BMW M4 Coupe 2015

Technical Service Bulletin: S1 B51 36 15

Service Action: Repair the PVC seam on the left rear light

F82 (M4 Coupe)

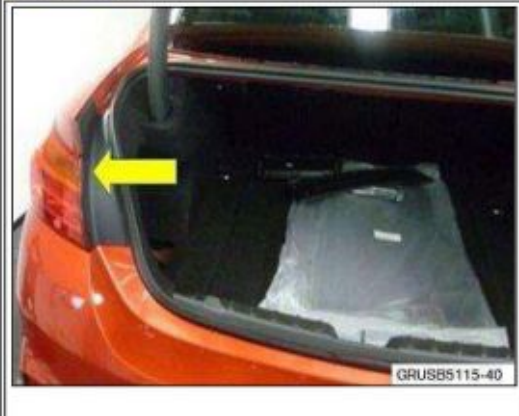
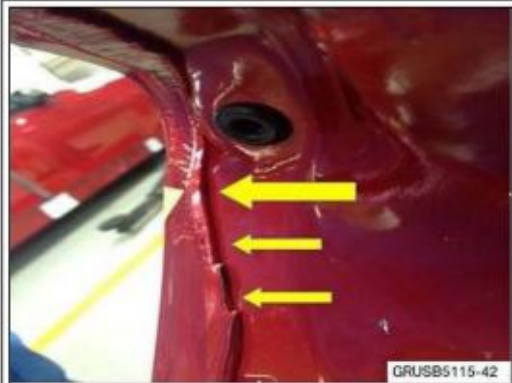
The left rear light PVC seam may not have been applied properly and may be leaking.

The PVC seam was not applied correctly and can cause water leaks.

Remove the left tail light and properly apply the PVC sealer.

| | <ol style="list-style-type: none"> 2. Seal the area of the PVC seam that shows waviness or is incomplete. |

3. Do not remove the existing PVC seal and only apply PVC sealer to the wavy area.
